Technical Bulletin

Installation: Reduced front servicing clearance

REDUCED FRONT SERVICING CLEARANCE CRITERIA ON WORCESTER 2000 SERIES, GREENSTAR I ERP SERIES, SI/CDI COMPACT ERP SERIES AND RI ERP+ SERIES APPLIANCES.

Fig. 1 Side view

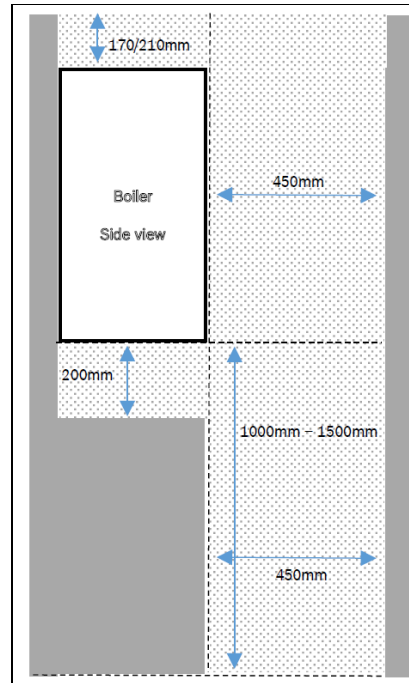
Providing all of the following criteria can be met, this can be reduced to 450mm.

- ▶ The bottom of the appliance case must be between 1000mm and 1500mm from the floor.
 - ▶ There must be at least 450mm clearance in front of the appliance to floor level. Anything which is sited below the appliance must not protrude into this clear space.
 - ▶ There must be at least 200mm clear space to any object which is sited below the appliance.
 - ▶ There must be at least 300mm clear space to either the left hand or right hand side of the appliance. This clear space must be from the required clear height above the appliance to floor level.*
 - ▶ There must be 170/210mm clearance above the appliance to accommodate 100mm/125mm flue accessories respectively.
- Note: *This clearance will not apply if the boiler is sited within 300mm of a door way and the door frame is the only obstruction.

Fig. 1 shows clearances required in front of and below the appliance and the height requirements to the bottom of the superstructure if the front clearance is reduced to <600mm.

Fig. 2 Front View

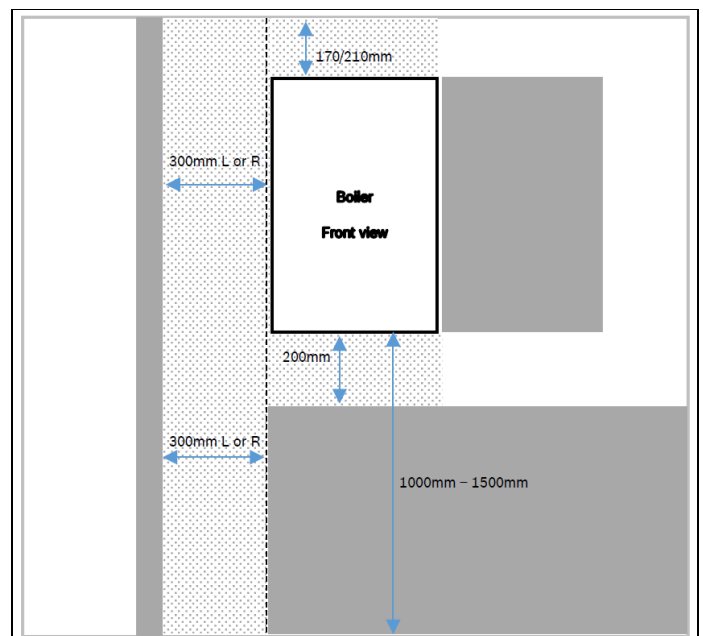
Fig. 2 shows the clearance required to the left hand or right hand side of the appliance if the front clearance is reduced to <600mm

Minimum clearances **must** be observed to any obstruction or structure (Dark shaded areas).
